MEETING NOTICE – VILLAGE BOARD (Regular)

Date/Time: Tuesday October 4th 2022 (6:00 P.M.)

A. INFORMATIONAL - New 11,890 square foot commercial building and associated site improvements (3828 Packerland Dr., HB-950-7) (Site Review Committee) (Page 16)

B. INFORMATIONAL - New 25,256 square foot commercial building and associated site improvements (4950 Founders Ter., HB-524-1) (Site Review Committee) (Page 46)

BUILDING ELEVATION - WEST
1 / A2.0 SCALE = 1/8" = 1'-0"

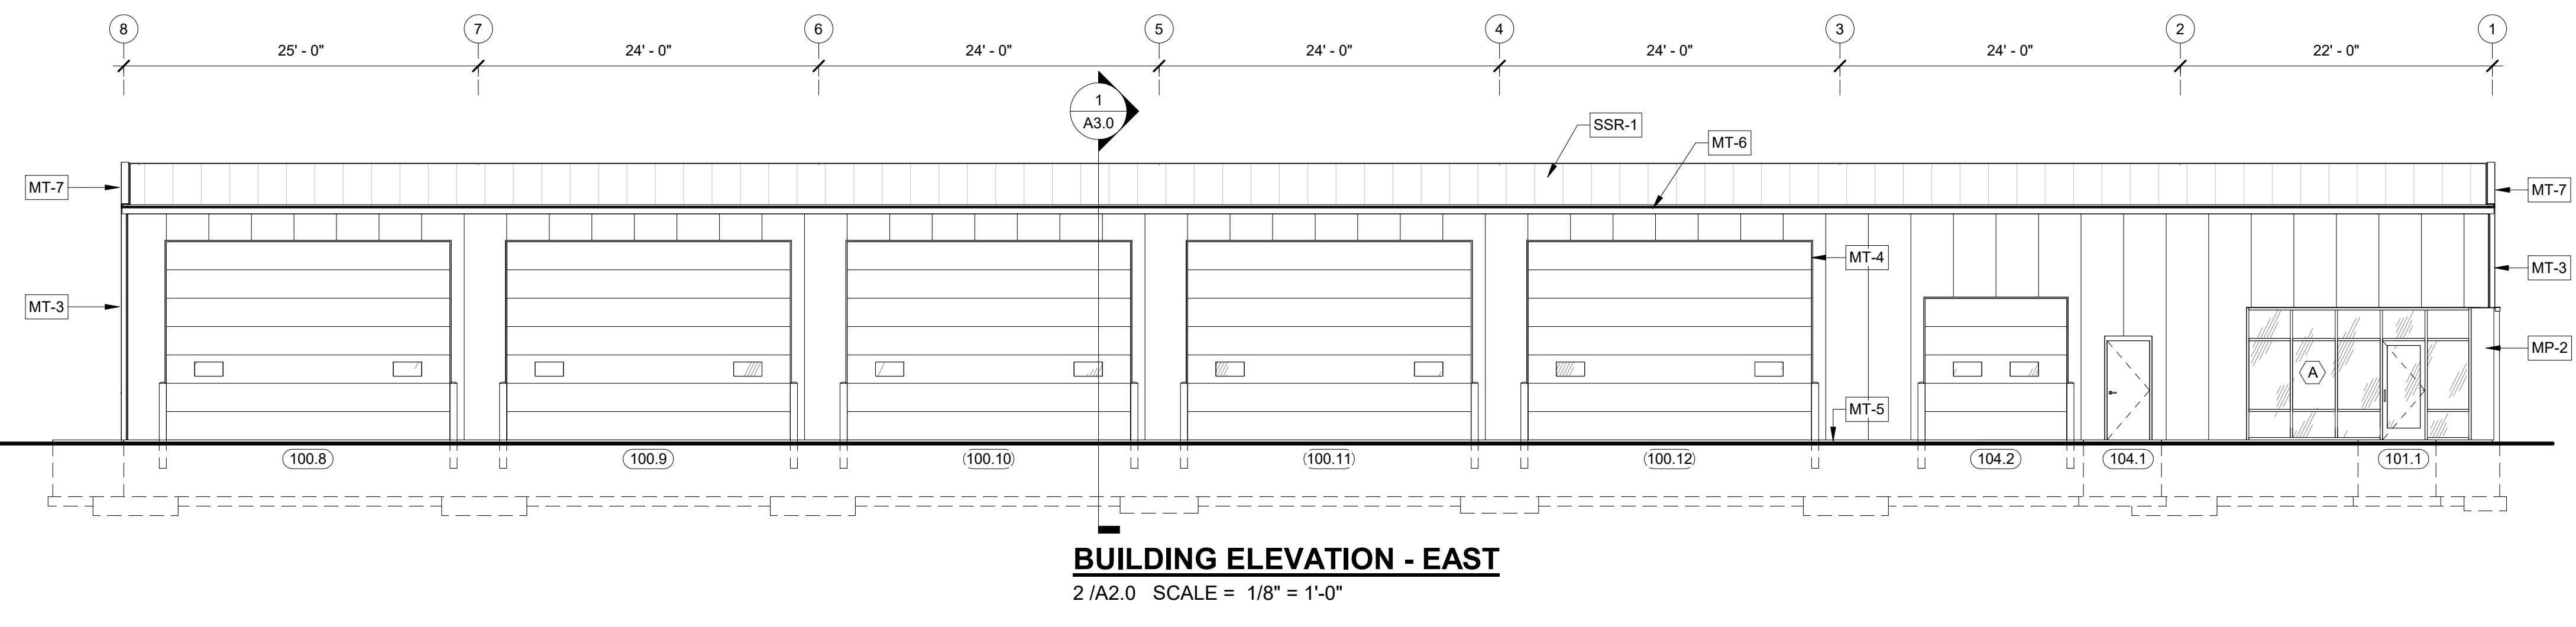
1. **Materials:** Metal frame building
2. **Exterior Materials:** Front wall of building facing Packerland Dr. will have a combination of split face CMU veneer and semi-concealed fastener metal wall panel wall panels. As for the percentage of masonry along the front elevation, the plan meets the minimum 35% masonry along the front elevation of the building.
3. **Height:** Overall height of 19'-5"
4. **Overhead doors:** All overhead doors on located on the north and south building elevations which are both side walls of the proposed building.
5. **Mechanical equipment:** There is no mechanical equipment shown, however, any roof mounted equipment shall be screened from view by materials compatible with the primary building.

LANDSCAPE PLAN

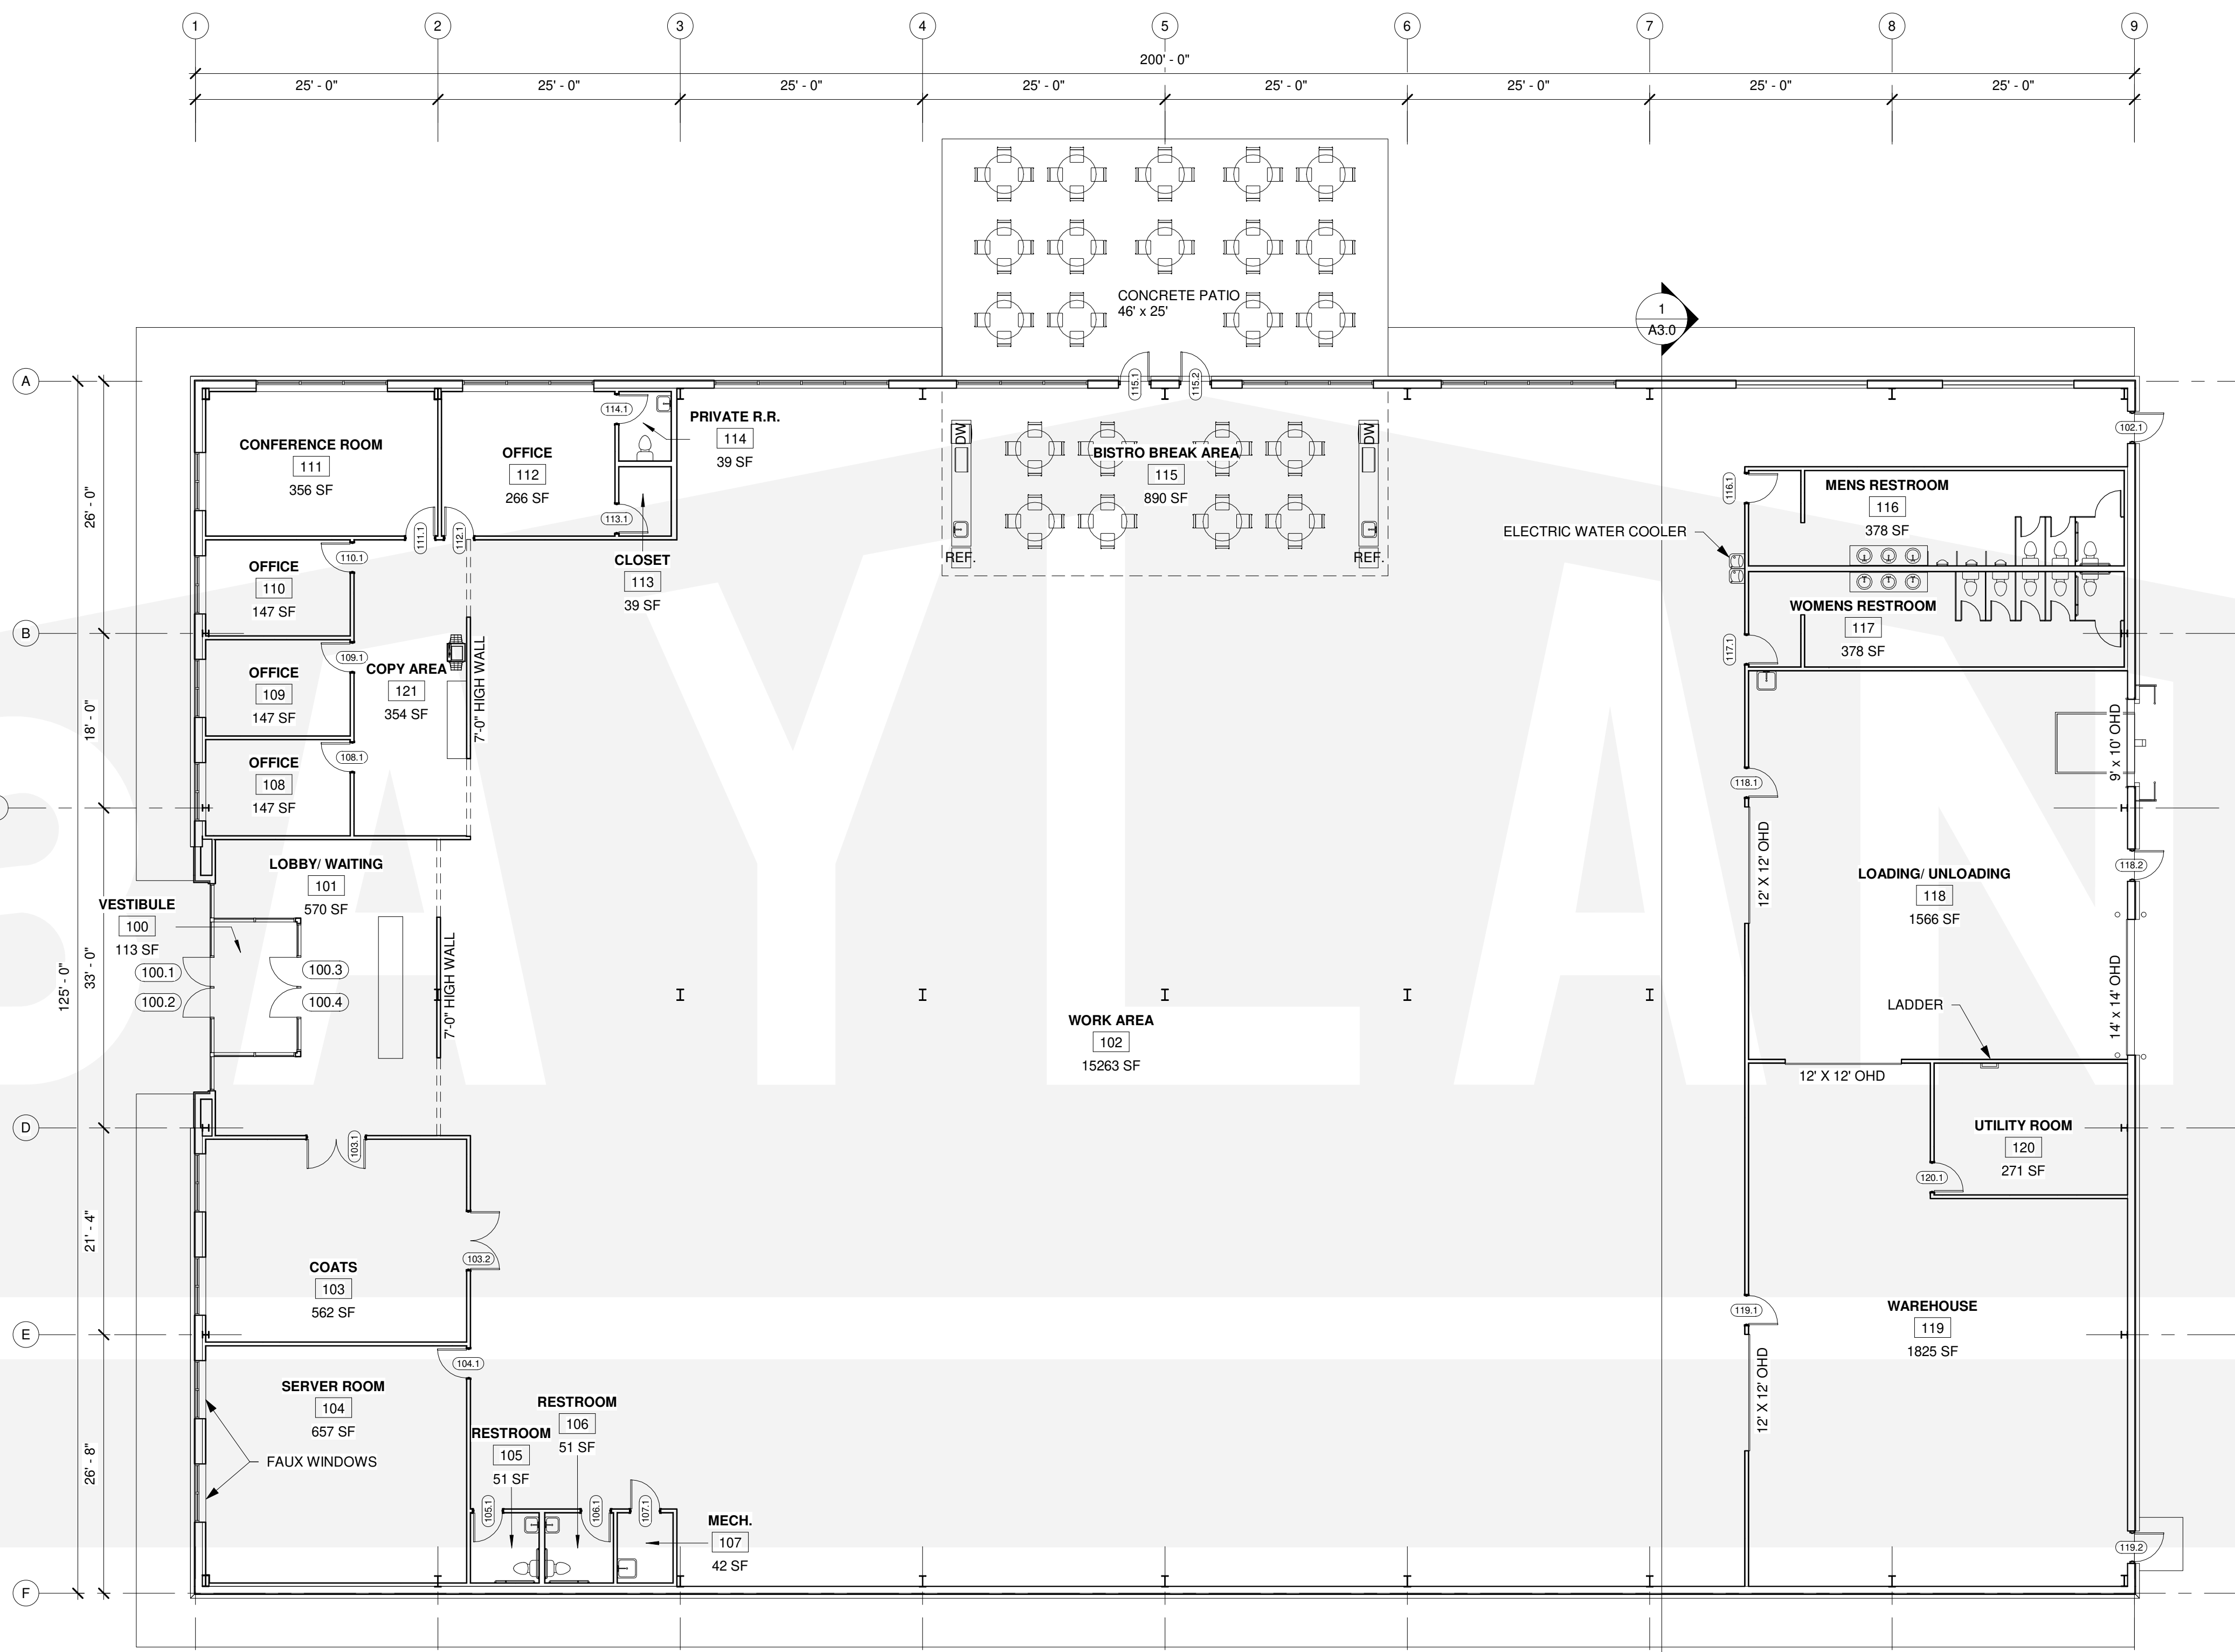
Section 3, Landscaping Plan: Required tree planting along the public roadway is noted on plan, however, a additional landscaping is recommended around the refuse/recycling enclosure and ground mounted mechanical equipment/backup generator to provide better screening of these areas.

1. Detailed on construction materials of refuse/recycling enclosure that are compatible with the primary building.
2. Additional landscape planting around south side of mechanical equipment /generator area and along south and east sides of refuse/recycling enclosure to screen from view from the public roadway.
3. Maintaining visual site lines for vehicular and pedestrian traffic at driveway accesses along Larsen Orchard Parkway.
4. Signage details shall be submitted for approval prior to installation.
5. Any additional mechanical equipment if located on the roof or ground, shall be screen from view by materials compatible with the building or landscaping.

1 / A2.0 SCALE = 1/8" = 1'-0"
WEST ELEVATION

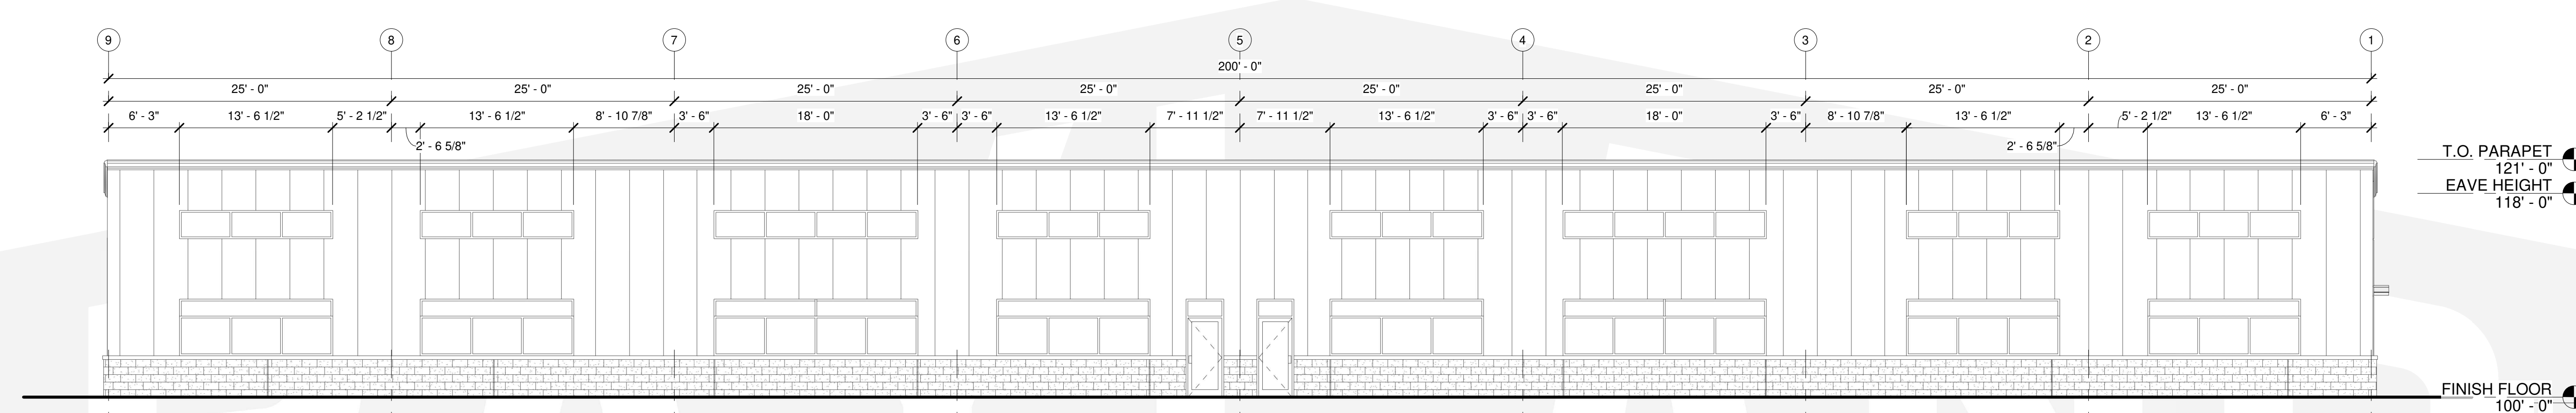
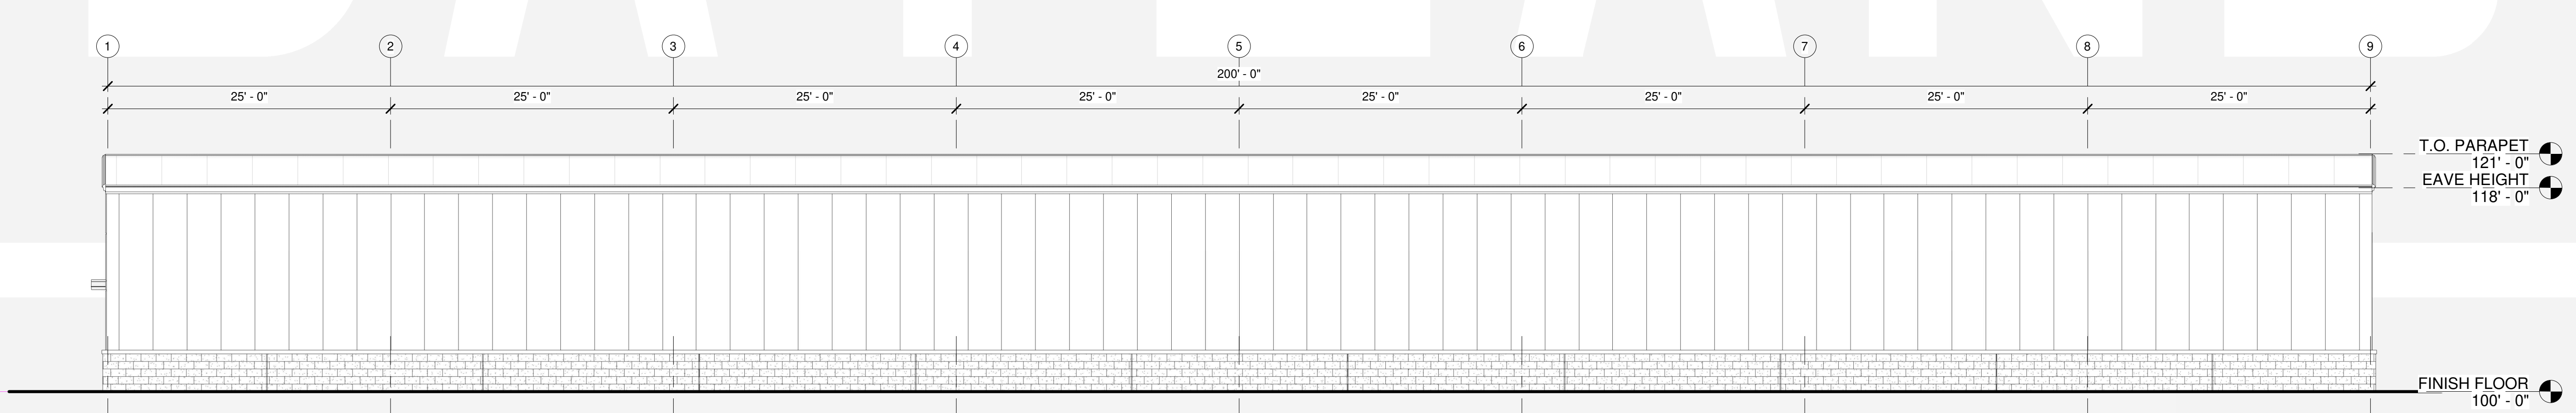
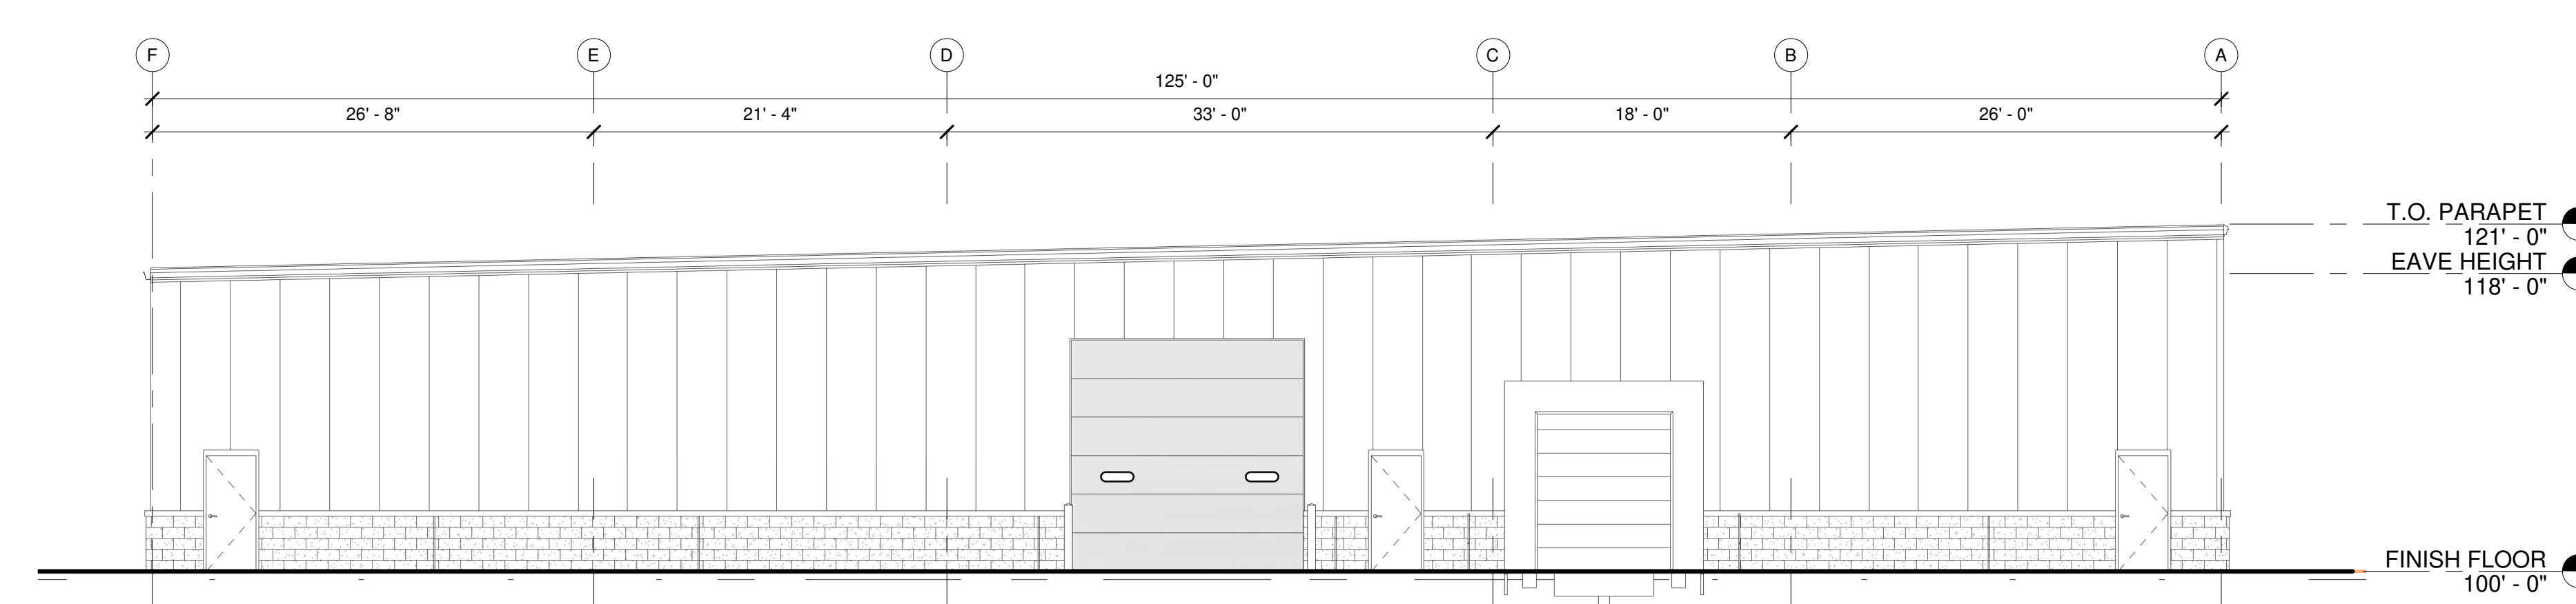
1. **Materials:** Metal framed building.
2. **Exterior Materials:** Proposed building materials consist of pre-finished smooth metal wall panels with 3'-8" high 4" spilt faced block veneer wainscoting on all four building elevations with pre-finished ACM panels around main entrance area on the front elevation.
3. **Height:** 21' to top of parapet wall
4. **Overhead doors:** Located on east elevation of building along Larsen Orchard Parkway.
5. **Mechanical equipment:** Mechanical equipment and backup generator are noted adjacent to the rear of the building and additional planting are recommended to screen the equipment from public view.
